RE: Case No. 2011-00295
Kentucky Power Company

**FINAL REPORT
To
THE KENTUCKY PUBLIC SERVICE COMMISSION**

**Focused Review of Documentation Filed by Kentucky Power Company
for a Proposed 138kV Transmission Line from Soft Shell Substation to
Bonnyman Substation
Case No. 2011-00295**

October 31, 2011

Bonnyman-Soft Shell 138 kV EMF Profile*

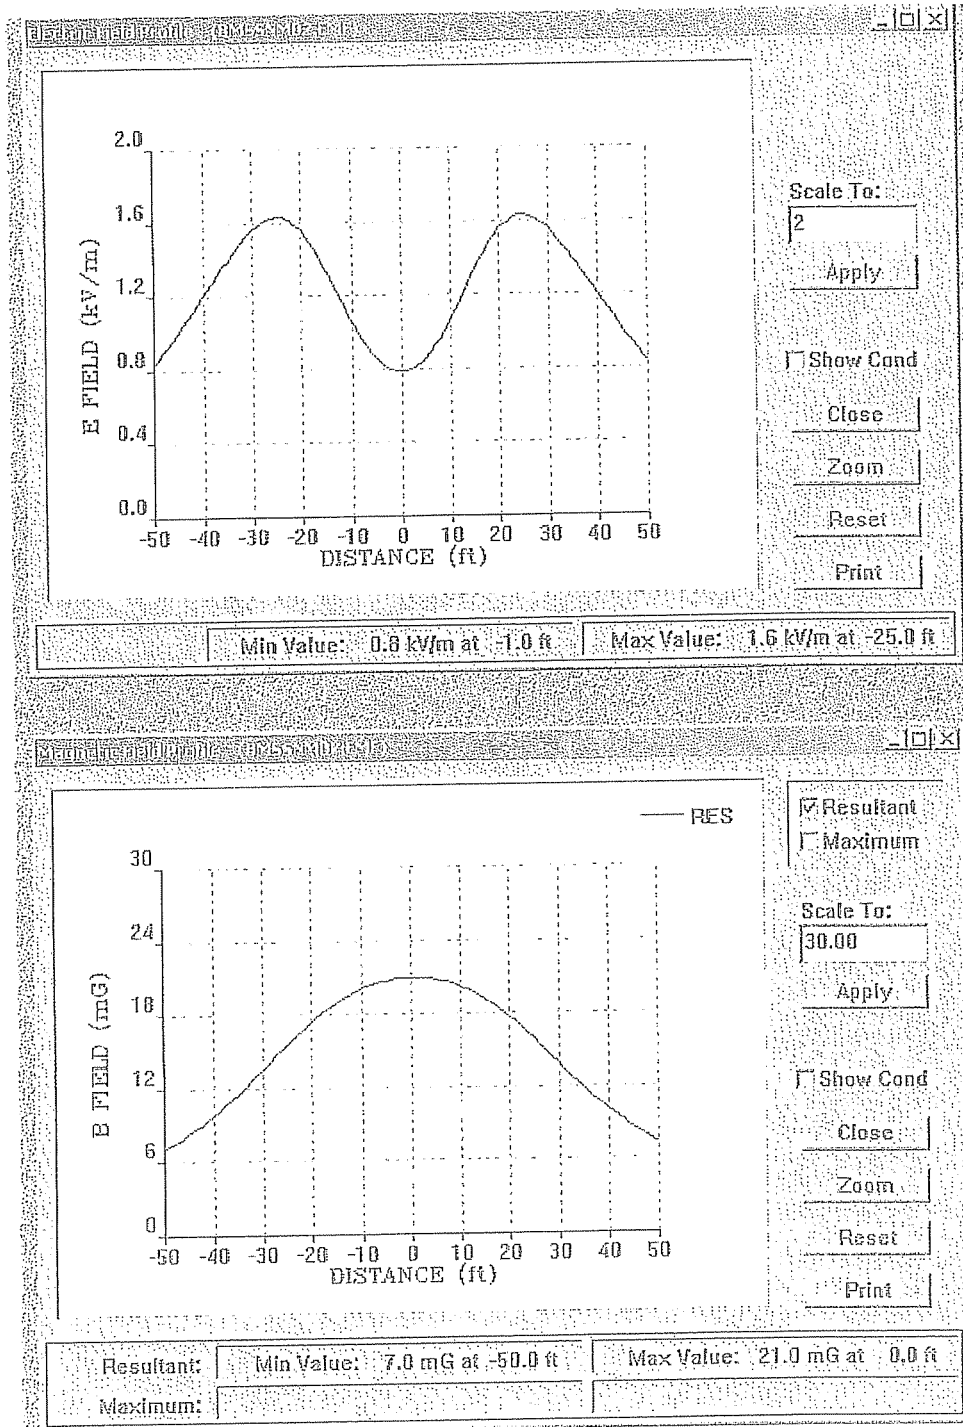
EMF effects are computed at the ROW edges (50 feet in each direction from centerline) for three configurations planned in the project (shown as Exhibits 4, 5, and 6 of the Application). The double-circuit design is a typical lattice structure that will support segments of the new 138 kV line and the existing Shamrock-Bulan 69 kV line for approximately one mile of the 20 mile line. The 138 kV single-circuit designs -- an H-frame structure and a three-pole structure -- will be used in the remaining parts of the project. Note that the three-pole structure has horizontal insulator posts, resulting in asymmetrical placement of phase conductors with respect to the right-of-way (ROW) edges of the line.

Normal maximum loading levels, representing peak load conditions, are assumed in the analysis to maximize the calculated EMF effects. No trees, shrubs, buildings or other objects that can block EMF are assumed in proximity to the proposed lines. Nominal voltages and balanced conditions are assumed, with currents flowing in the directions expected during normal system operation. Since the aforesaid 138 kV and 69 kV lines normally will carry power in the same direction, a phase configuration known as "low reactance" (A-B-C/C-B-A, top-to-bottom) is planned for the double-circuit segment, resulting in lower EMF. All calculations are obtained at the height of 3.28 feet (one meter) above ground using the Electric Power Research Institute (EPRI) EMF Workstation "Enviro" computer program. The results are summarized in the table, below.

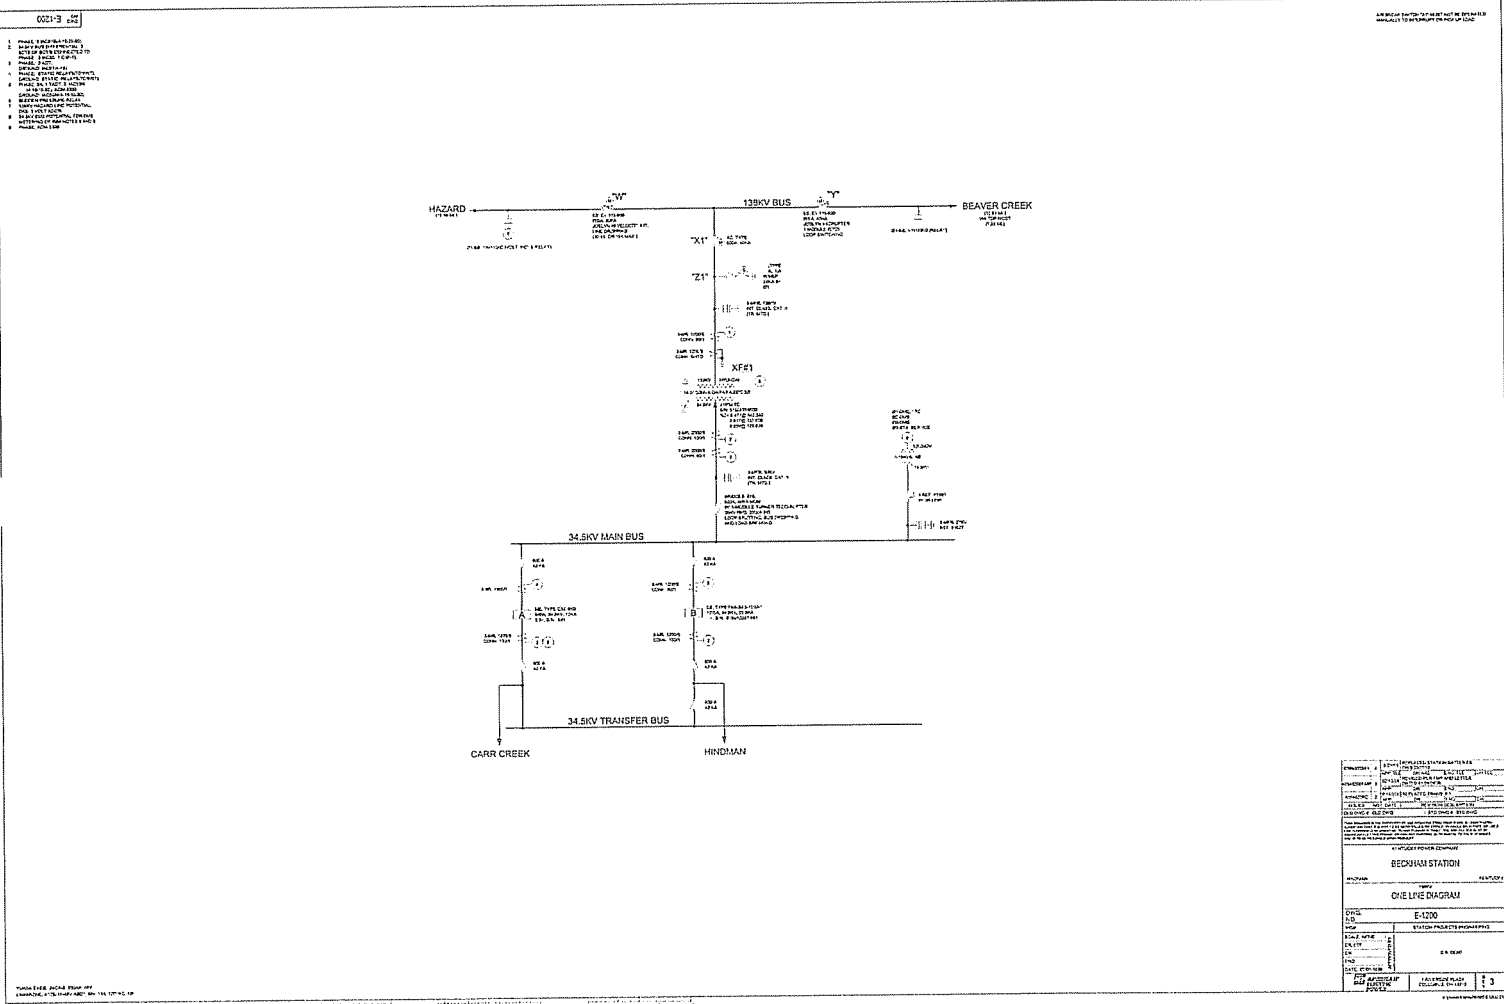
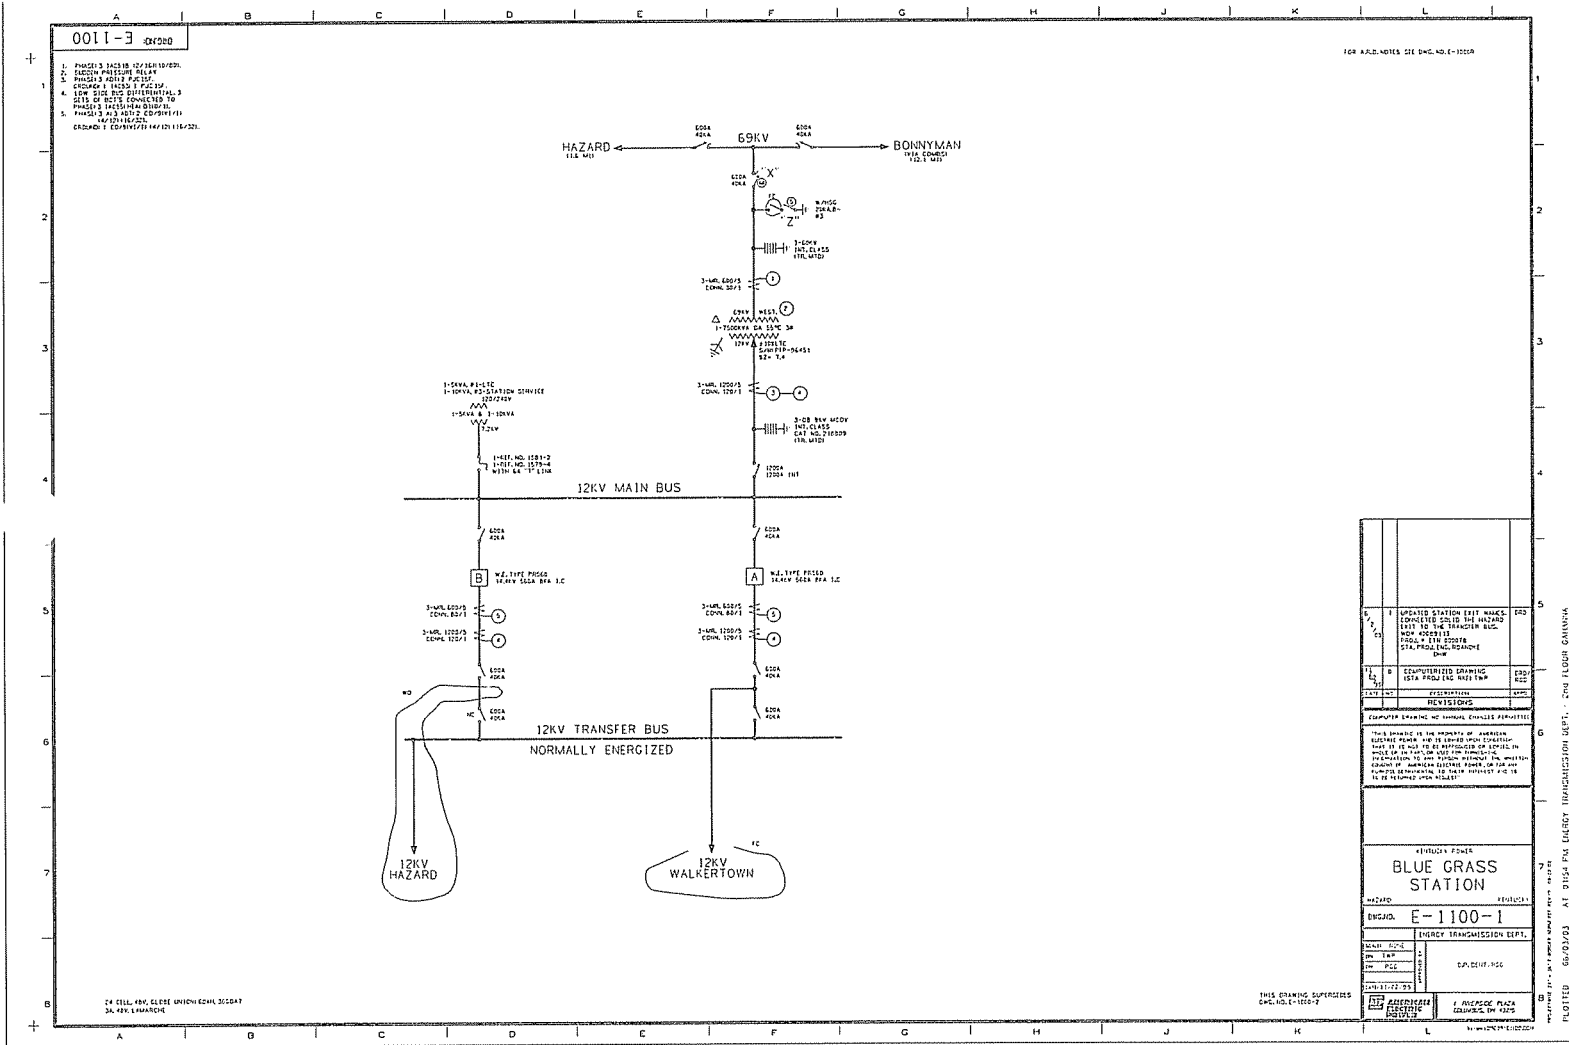
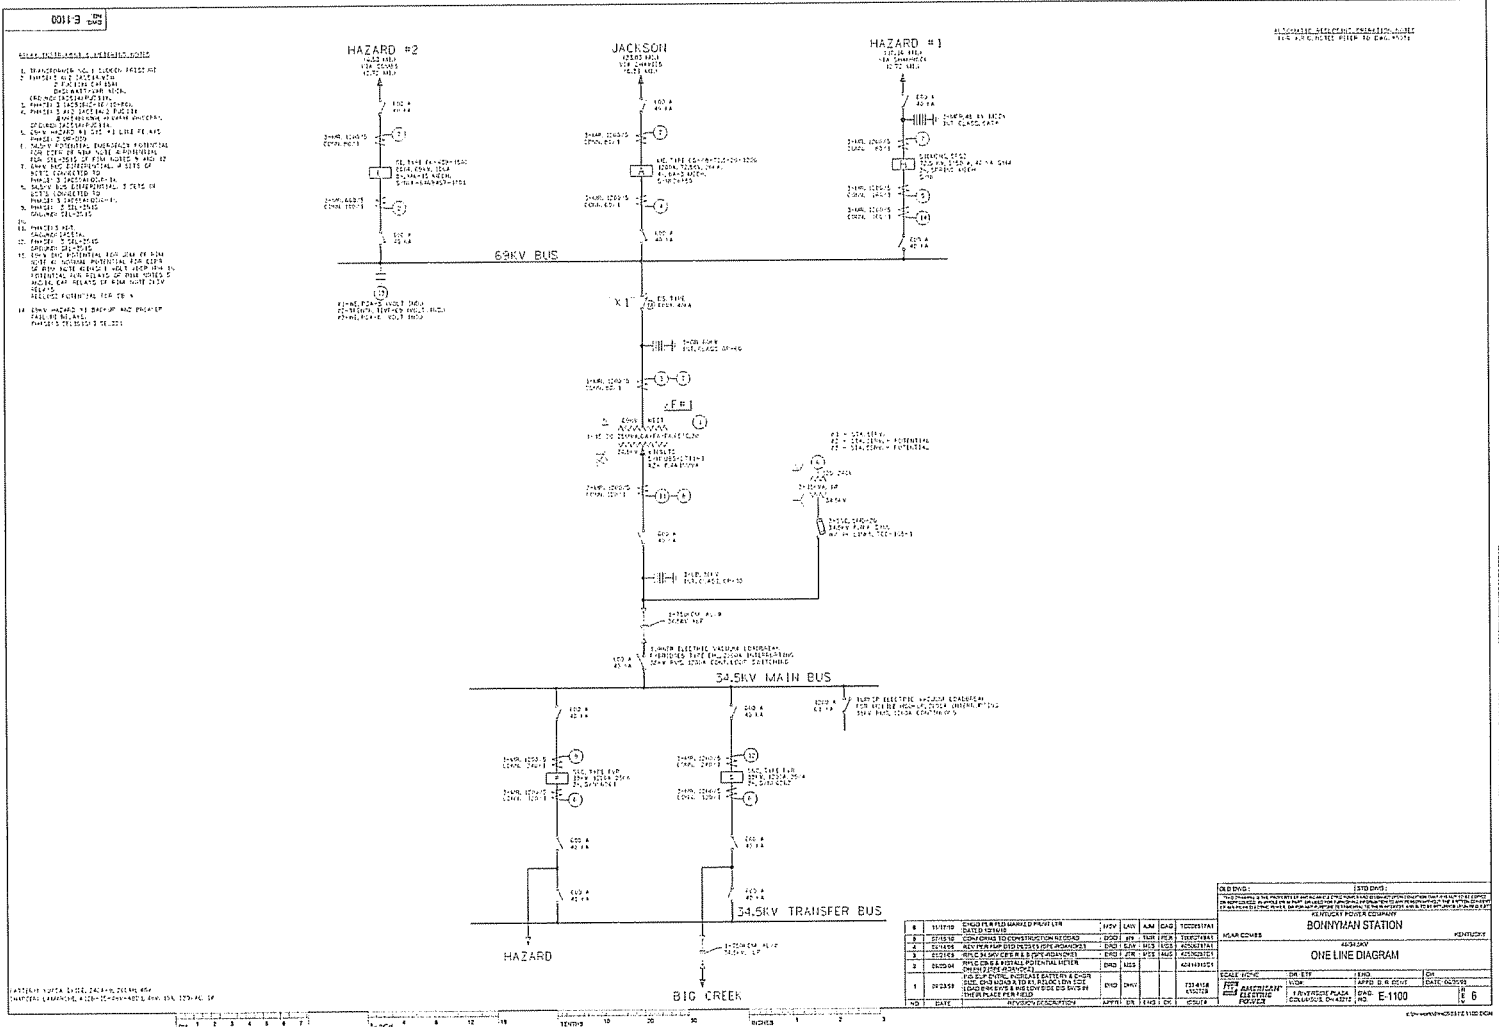
3. Please supply one-line system diagrams for the KP transmission and sub-transmission power systems. These diagrams should show substation breaker configurations.

The one-line diagrams of KP stations involved in the limiting contingency(ies) are attached below.
